Product Change Notification / MFOL-07PXJU937

CCB 6233 Final Notice: Qualification of 95x155 mils leadframe paddle size for selected AT25512 and AT25M01 device families available in 8L SOIC (3.90mm) package at ANAP assembly site.

# Pre and Post Summary – Leadframe drawing/lay-out comparison

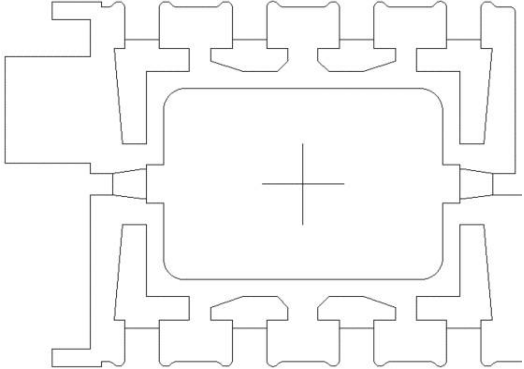
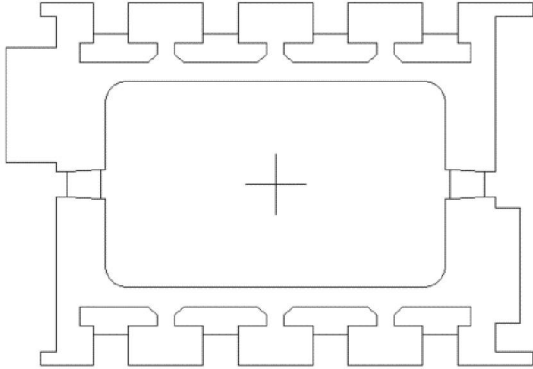
ANAP	ANAP
 <p>Leadframe Paddle Size   90x130mils</p>	 <p>Leadframe Paddle Size   95x155mils</p>
